# Woodland Hill ~ Warner Center Neighborhood Council Planning, Land Use, and Mobility Committee May 19, 2022

DIR-2021-9388-DRB-SPP- MSP; ENV-2021-9389-CE Design Review Board, Project and Permit Compliance - Major

**PROJECT LOCATION** Street Address 4810 Galendo St., Legal Description Lot, Block, Tract 2789, U, 6170, Assessor Parcel Number 2171 008-013. The project is within the baseline hillside ordinance area, the Girard Tract, and Mulholland Scenic Parkway Outer Corridor.

Lower right: Roof

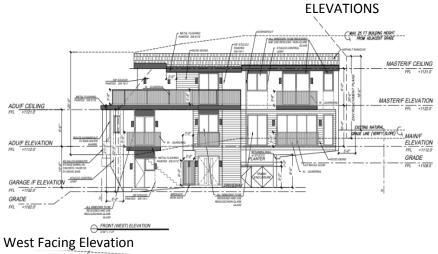
**Guideline 35: Roof form.** Flat roofs should not be utilized, particularly on downslope lots. Roofs should be designed to follow the predominant slope of the land. Where a flat roof must be proposed, a secondary roof form should also be utilized, covering at least 30 percent of the total roof area and offset a minimum of 4'-0" from the flat portion, measured vertically. N Roof Plan. The Applicant needs to provide a roof plan.

North Facing Elevation

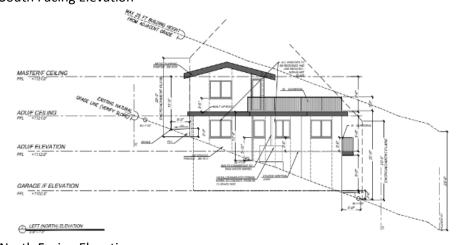
- 10. Comments from PLUM members feel the building looks boxy, uninspired, and 1950s-ish.
- 11. The height of the house can be acceptable if the house otherwise is found in conformance with the Mulholland guidelines, No. 32, 34, and 35.

**Guideline 34: Building articulation.** Design the exterior surface (building elevations) of any structureto be articulated, presenting a variety of surfaces, textures, and angles. Avoid designs that include exterior or retaining walls characterized by large, flat surfaces. Boxy houses with flat sides are not considered acceptable.
